IN THE DRAWINGS

REMARKS

This application has been allowed. Applicants respectfully request, however, that the Examiner additionally enter this Amendment Under 37 C.F.R. § 1.312(a) to correct for typographical errors.

FIG. 4

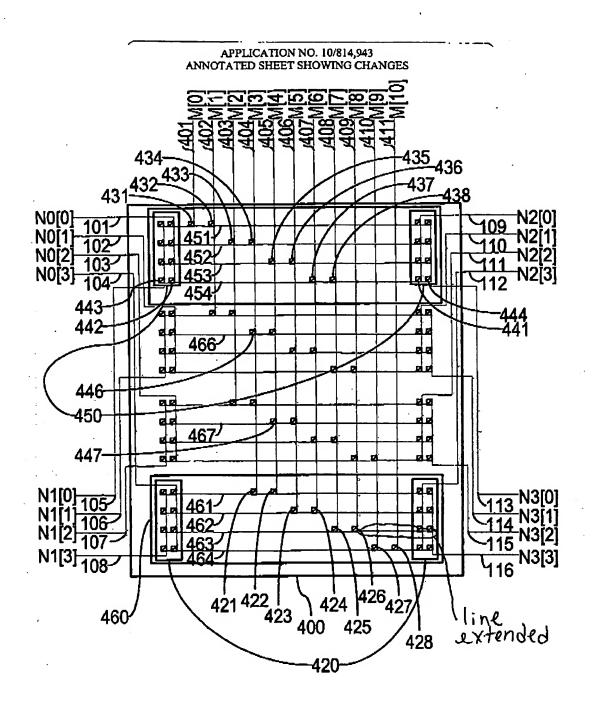
The attached drawing sheet includes a change to Figure 4. The sheet which includes Figure 4 replaces the original sheet including Figure 4. The figure has been amended to extend the line 463 to the right to intersect the switches in sub-network 420. It is respectfully submitted that the proposed amendment to the drawing does not add new matter.

Figure 4 has been amended to correct for an error by extending line 463 to the right to intersect the switches of 420. Support for the amendment of Figure 4 may be found in the paragraphs 0037 and 0038 which describe that line 463 connects to conductors 112 and 116 through switches in sub-network 420.
